**CITY PLAN COMMISSION****THURSDAY, FEBRUARY 19, 2025****RECORD NO.:** PLAT-26-000024**SENIOR PLANNER:** Sharmila Shrestha**LOCATION:** Turner Avenue, north of Colorado Boulevard**DATE FILED:** January 22, 2026**ZONING:** CD-13 (Subarea 3)**CITY COUNCIL DISTRICT:** 1**SIZE OF REQUEST:** 5.6404-acres**APPLICANT/OWNER:** Kessler Park Methodist Church

**REQUEST:** An application to create one 0.5401-acre lot, 0.5072-acre lot, and 4.5931-acre lot from a 5.6404-acre tract of land in City Block 5925 on property located on Turner Avenue, north of Colorado Boulevard.

1:3,600	<h3 style="text-align: center;">AERIAL MAP</h3> <ul style="list-style-type: none"> <li><input type="checkbox"/> Area Of Request</li> <li><input type="checkbox"/> Recent History</li> </ul>	Case no: <u>PLAT-26-000024</u> Date: <u>02/02/2026</u>
--	---	---

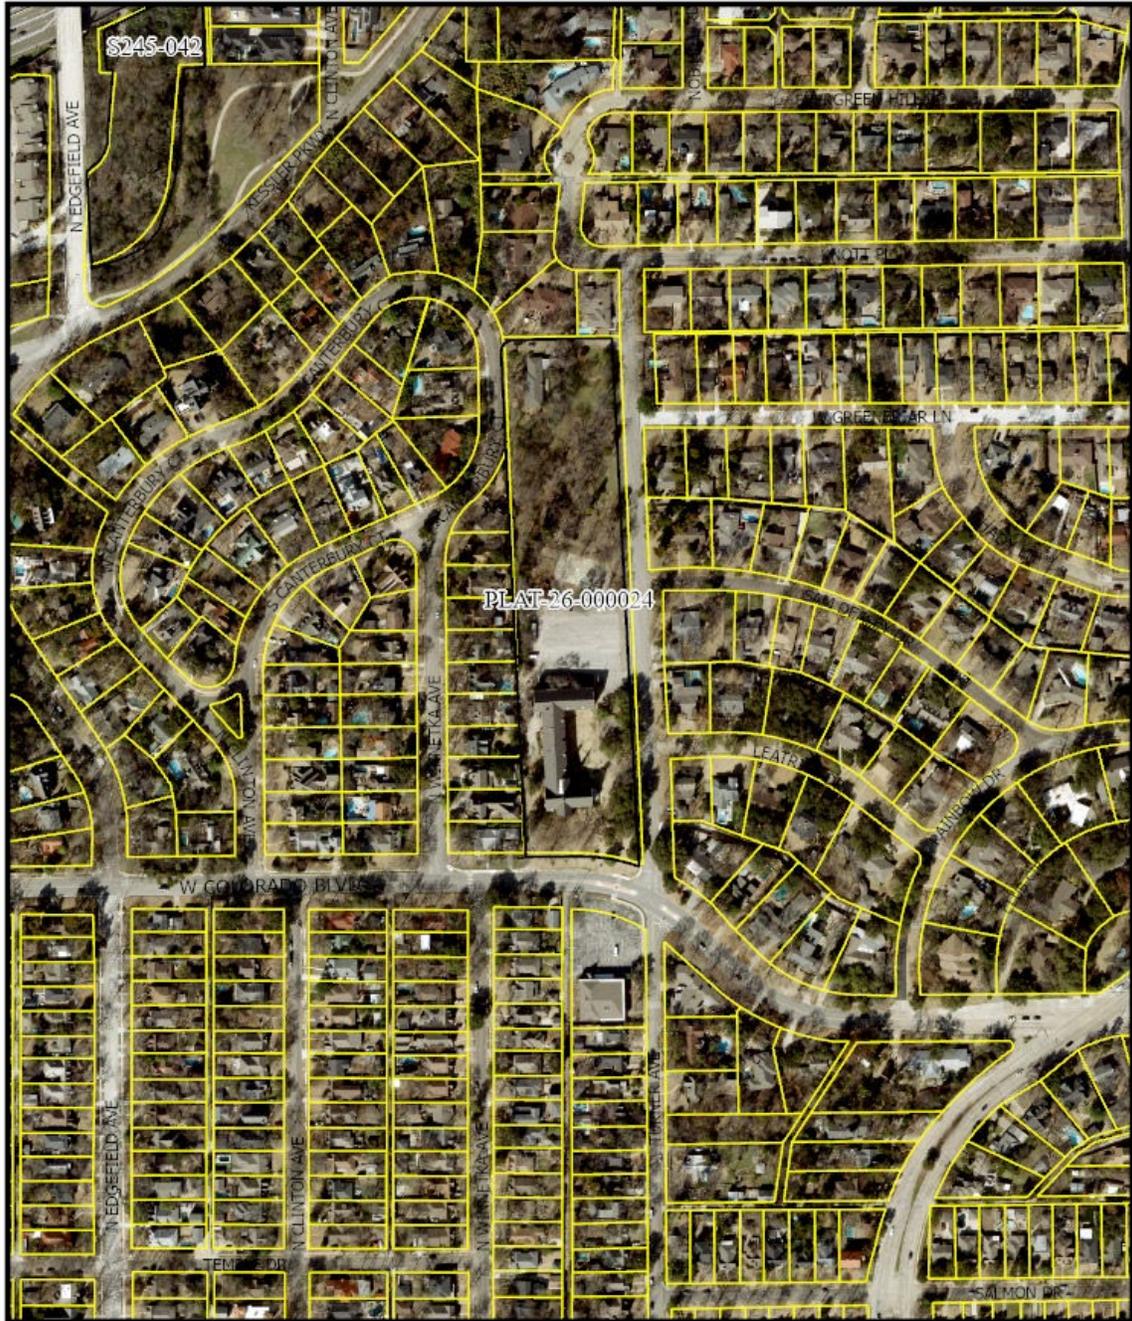
22. Additional design information needed to complete review. Provide a brief description of the proposed project and a copy of the site plan to [daniel.silva@dallas.gov](mailto:daniel.silva@dallas.gov) to determine street lighting requirements.
23. On the final plat, change "Greenbrier Lane" to "Greenbriar Lane".
24. On the final plat, identify the property as Lots 1, 2, and 3 in City Block A/5925.
